944-SPEC - 944SPEC - low cost wheel to wheel racing

Body (6-10) Posted by joepaluch - 07 Nov 2009 22:57

These are PROPOSED changes gather from the various discussions. Use this area to further discuss these. Based on the feedback we get the rules will be changed (or not) to reflect these updates. It is anticipated that some rules changes will NOT be accepted, but all are up for debate.

9 Lexan Windshield

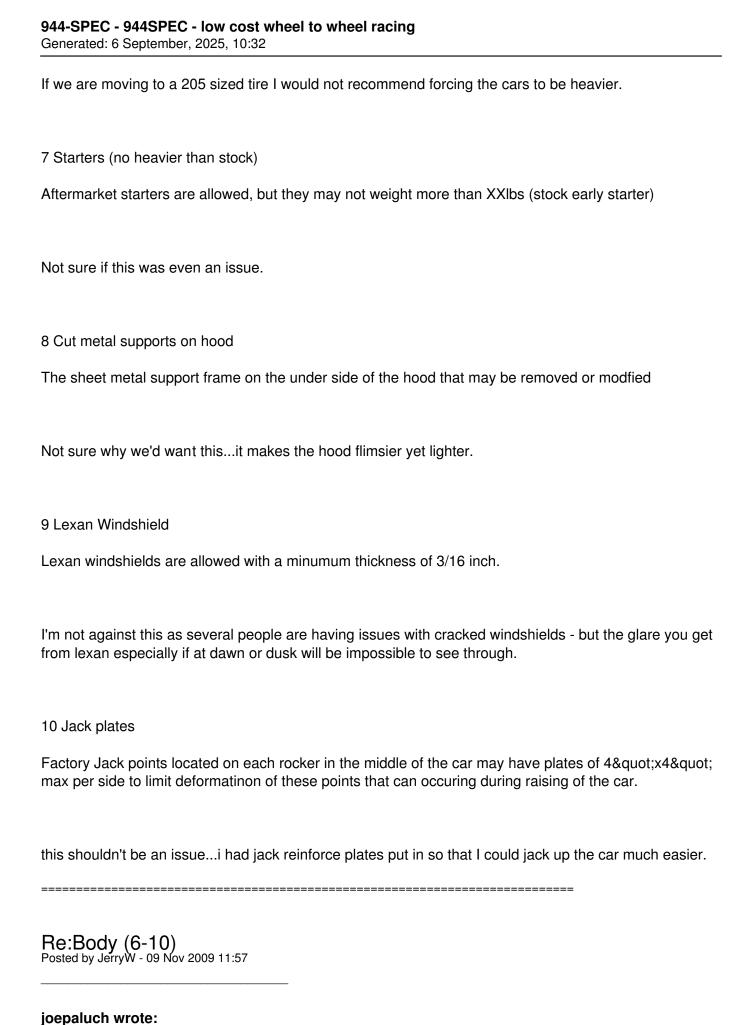
Lexan windshields are allowed with a minumum thickness of 1/4 inch. (EDITED 11/24/09, Was 3/16)
